SUBJECT: Mandatory Referral MR 04107-MCPS-1
Northeast Consortium School # 16
Brookview Elementary School
Silver Spring/Takoma Park Policy Area

SUBJECT: Forest Conservation Plan for
Mandatory Referral No. MR-04107-MCPS-1
Northeast Consortium Elementary School Number 16
Brookview Elementary School

SUBJECT: Comments on Brookview Elementary School Mandatory Referral

Forecast Intersection Congestion

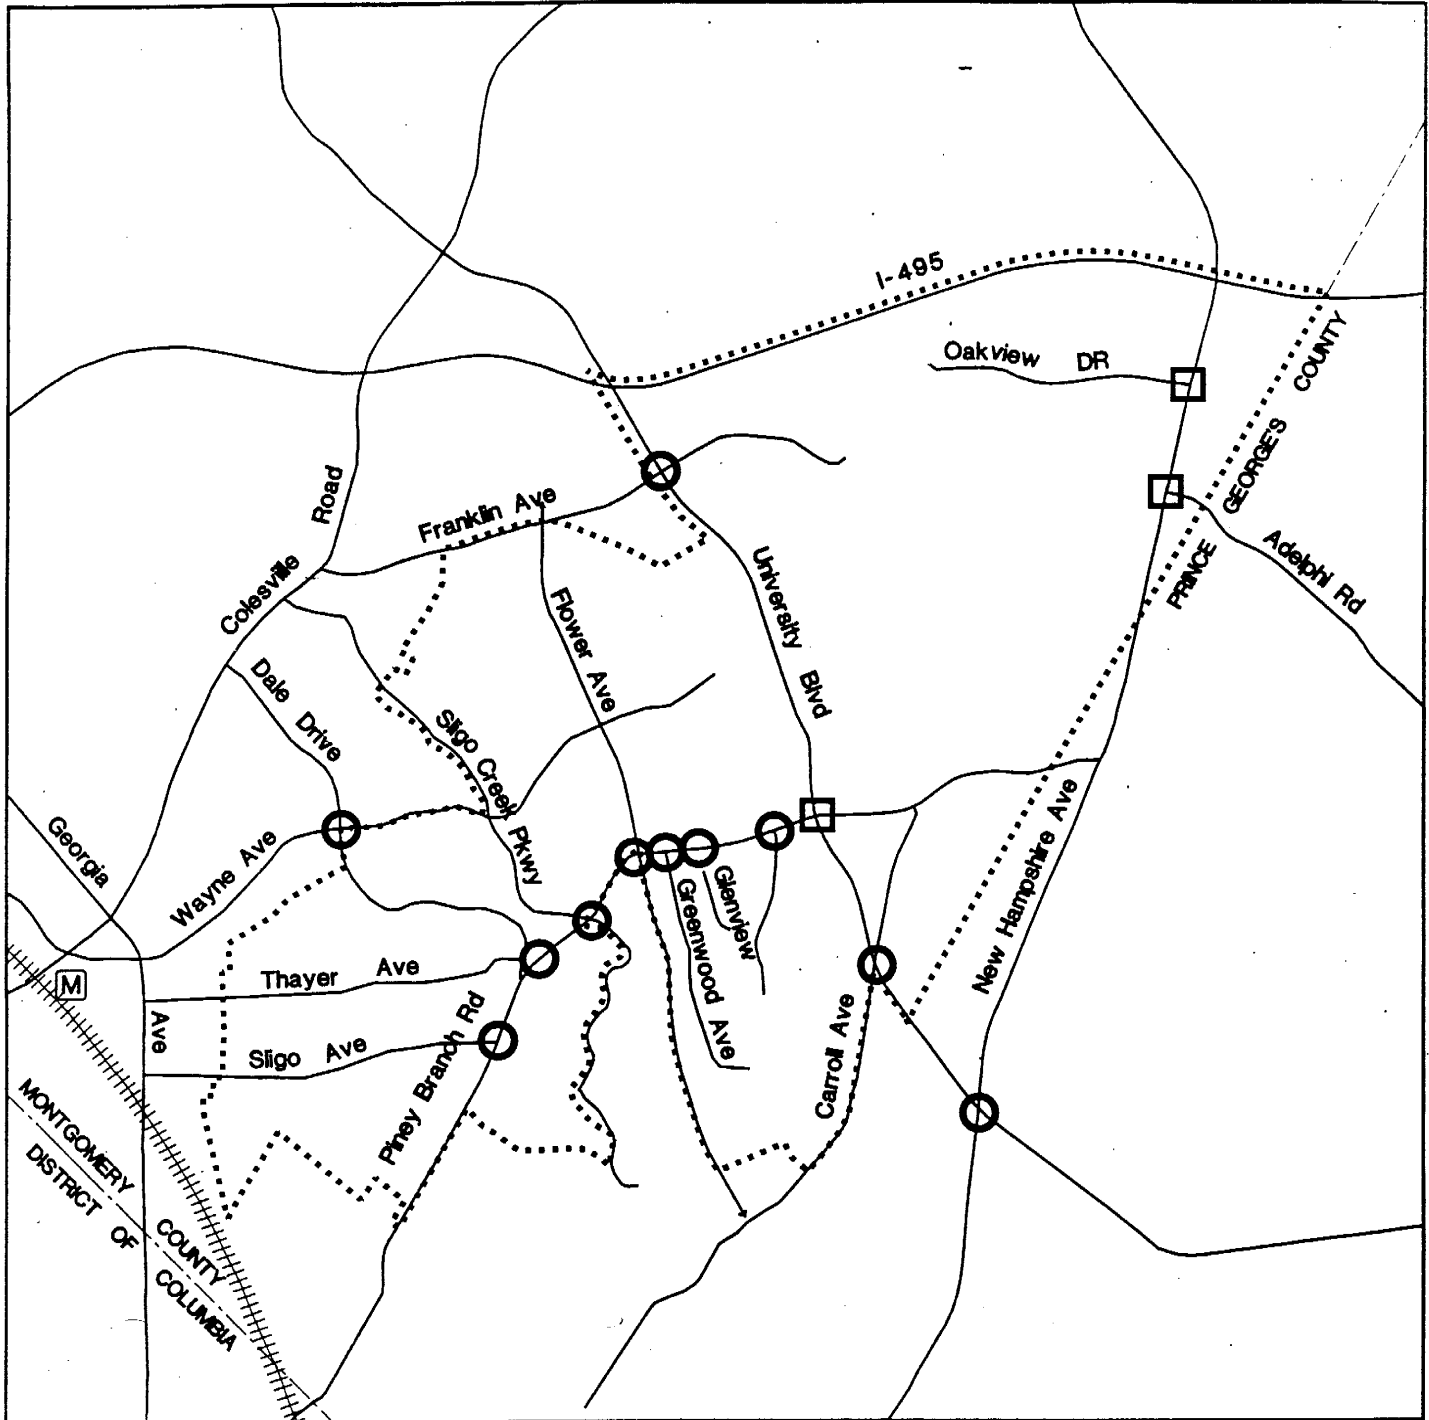
The *Master Plan* identifies the two study area intersections, New Hampshire Avenue at Oakview Drive and at Dilston /Adelphi Road, as forecast to exceed congestion standards by year 2020 and makes recommendations for improvements, including additional through travel lanes on New Hampshire Avenue and turning lanes on both the major and minor approaches.
